ReDirect Recycling Pty Ltd – SSD10474 - 25 Dunheved Cct, St Marys

Response to Agency Comments – 08/09/21

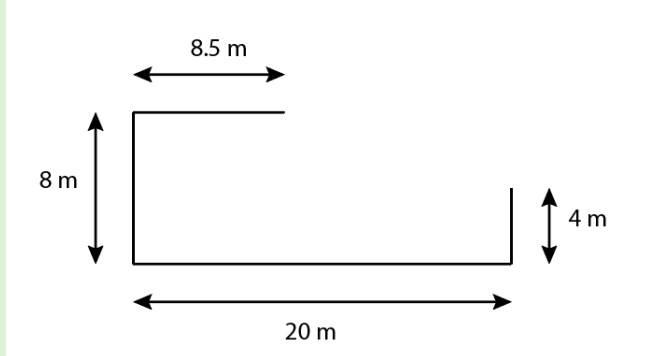
3	Waste Management	DPIE	Please provide the dimensions of the plasterboard waste storage bay to demonstrate how the 456 m ³ volume, identified in Table 3.6 of the updated Waste Management Plan, is achieved.	<p>The approximate dimensions of the plasterboard bunker is given below. This layout provides a floor area for storage of approximately 114 m². At a maximum stockpile height of 4 m, the volume would be 456 m³.</p>
